July 6, 2017

Re: Docket No. 70-925; License No. SNM-928  
Removal of Burial Area #2 Remediation from Decommissioning Plan

Exhibit 1

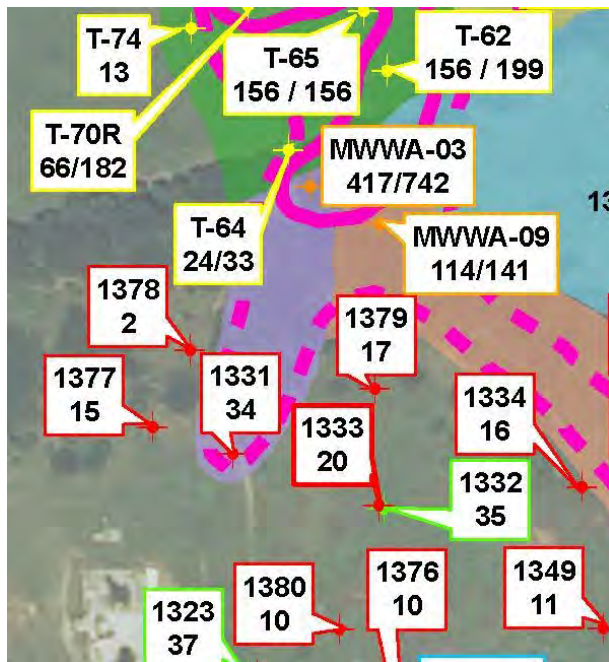
Exhibit 1 shows the locations of monitor wells in and around BA2. Monitor Wells 1331 through 1333 were installed in March 1989 as part of a site-wide radiological investigation; the installation and initial sampling of these wells was reported in the 1989 *Site Investigation Report*. Additional groundwater samples were collected from these wells for laboratory analysis during development of the 1995 *Decommissioning Plan*. The collection and analysis of groundwater samples from these wells continued through the ensuing years.

As Exhibit 1 shows, only one of the five monitor wells (Monitor Well 1331) yielded a uranium concentration exceeding the MCL in 2015. The analytical uranium concentration result for this sample, collected in April 2015, was 34  $\mu\text{g/L}$ , slightly above the MCL. The extent of groundwater exceeding the uranium MCL in BA2, as depicted by the MCL iso-concentration contour shown above, was based exclusively on this MCL exceedance reported for Monitor Well 1331 (see Exhibits 1 and 2). Uranium concentrations reported for Monitor Well 1331 prior to 2015 also exceeded the MCL.

Exhibit 2

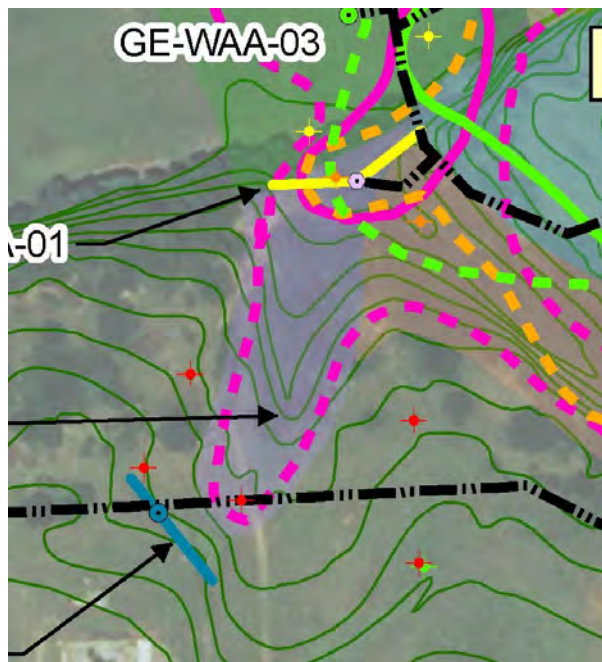
As shown in Exhibit 2, the 2015 *Facility Decommissioning Plan* included the construction and operation of a treated water injection trench (GWU-WU-02), represented by the blue line located west of Monitor Well 1331 (Exhibit 2). The blue circle near the center of the trench represents a treated water injection well installed within the trench. GWU-WU-02 was designed with a length

of approximately 177 feet and an average depth of approximately 19 feet below grade; the trench will be excavated within Sandstone A. The GWI-WU-02 trench design also provides for approximately 1,300 feet of buried piping (conveying treated water for injection) and instrumentation cable (for injection well water level monitoring) extending from the GWI-WU-02 injection well location to the Western Area Treatment Facility.

Hundreds of thousands of dollars will be required to install, operate, monitor, and abandon the GWI-WU-02 injection system for the purpose of remediating an area that now appears to comply with the DEQ criteria for unrestricted release. Therefore, we do not feel it is necessary to implement remediation in an area in which uranium concentrations appear to now comply with the DEQ criterion for uranium in groundwater.

Based on the above-described evaluation, EPM seeks your approval to remove this component of the groundwater remediation program. Please feel free to contact me at 405-642-5152 or to e-mail me at [jlux@envpm.com](mailto:jlux@envpm.com) if you have questions or desire clarification of any of this information.
